Tudor House, 35 Gresse Street, Camden, W1T 1QY

Justification to support the application for a non-material amendment to planning permission 2020/3062/P.

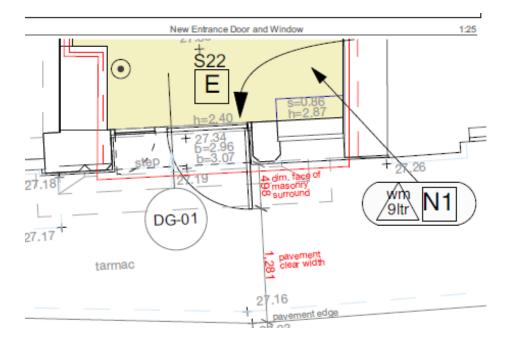
- 1.7 The existing doorway is outward opening and this arrangement has been in place for over 20 years in order to meet fire regulations. The proposed doorway simply seeks to replace the existing doorway with a modern entrance to upgrade the building.
- 1.8 Whilst the door opens outwards, the doorframe is set back from the pavement, with a step onto the highway so only half of the doorway (498mm), when opened, encroaches the footway. Over 1.28 metres of clear footway is still maintained when the door is fully opened. This arrangement is detailed in the plan below.

- 1.9 The longevity of this arrangement confirms the acceptability and lack of harm that this arrangement presents.
- 1.10 A plan has been prepared which details the doorframe and the level of projection. The drawings confirm that the encroachment onto the highway is minimal (as a result of the set back) and therefore the continuation of an outward opening door would not adversely impactpedestrian movement on the pavement.

- 1.13 Overall, it is considered that an outward opening door is acceptable and this should be facilitated through an amendment to the condition.
- 1.14 We request that condition 4 is worded as follows: "Prior to the beginning of the relevant part of the works, details of the front door shall be submitted and approved in writing. The details shall include the open/close mechanism and the manufacturer specification."
